DIVISION OF WATER RIGHTS

RE: EAST FORK OF VIRGIN RIVER

Possible Repair of Chamberlain Spring

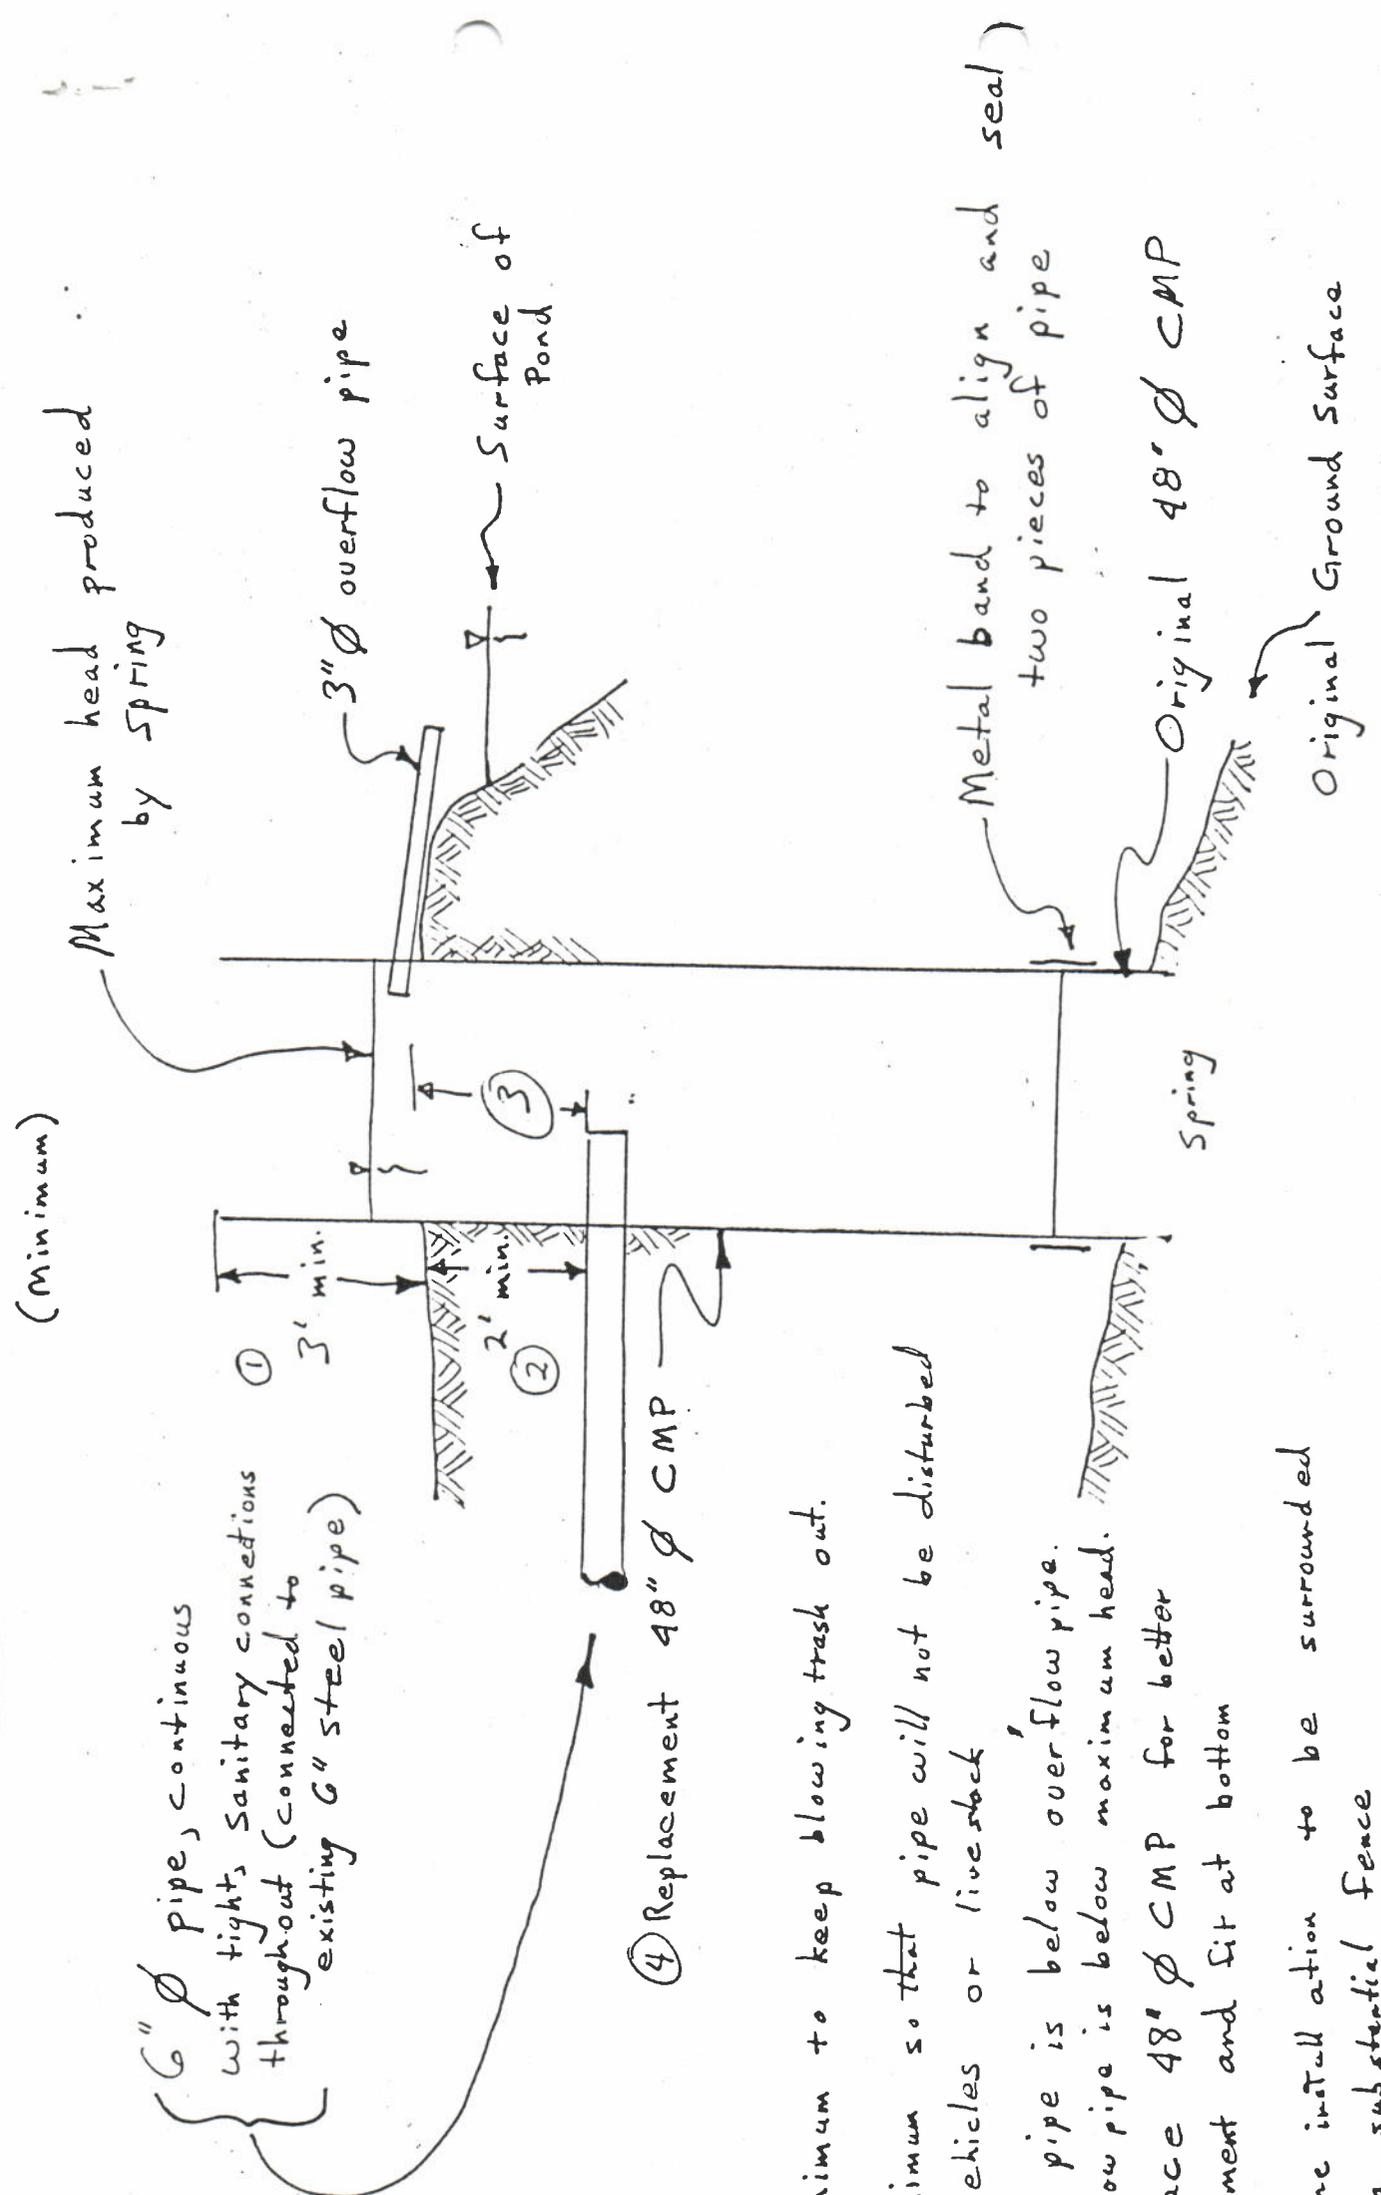
The Chamberlain's complaint is that when you built a certain small dam in Lydias Canyon you severed their waterline from the above mentioned spring to their home and that the water impounded behind the dam has inundated the spring. Remedial measures taken on your part to restore the flow to Chamberlain's home are not satisfactory to them or to this office. Gerald Stoker, Area Engineer, believes that you and Mr. Chamberlain have had sufficient time to correct this problem and that further delay is not in the best interest of those water users at the Chamberlain Ranch.

You are hereby ordered by the State Engineer to complete the repairs to the water system described above. The minimum that will be acceptable is a closed system that will prevent contamination of the Chamberlain's domestic water supply.

Enclosed is a sketch of one possibility that would meet our requirements. We will allow you thirty (30) days or until Jan. 10, 1979 to have these repairs and construction completed. If you choose not to comply with this order, we will take legal action to have the offending dam removed and the water system restored to preconstruction conditions.

- ① 3' minimum to keep blowing trash out.
- ② 2' minimum so that pipe will not be disturbed by vehicles or livestock
- ③ Inlet pipe is below overflow pipe. Overflow pipe is below maximum head.
- ④ Replace 48" \varnothing CMP for better alignment and fit at bottom
- ⑤ Entire installation to be surrounded by a substantial fence
- ⑥ CMP = Corrugated Metal Pipe = culvert
 \varnothing = diameter (ID or OD)
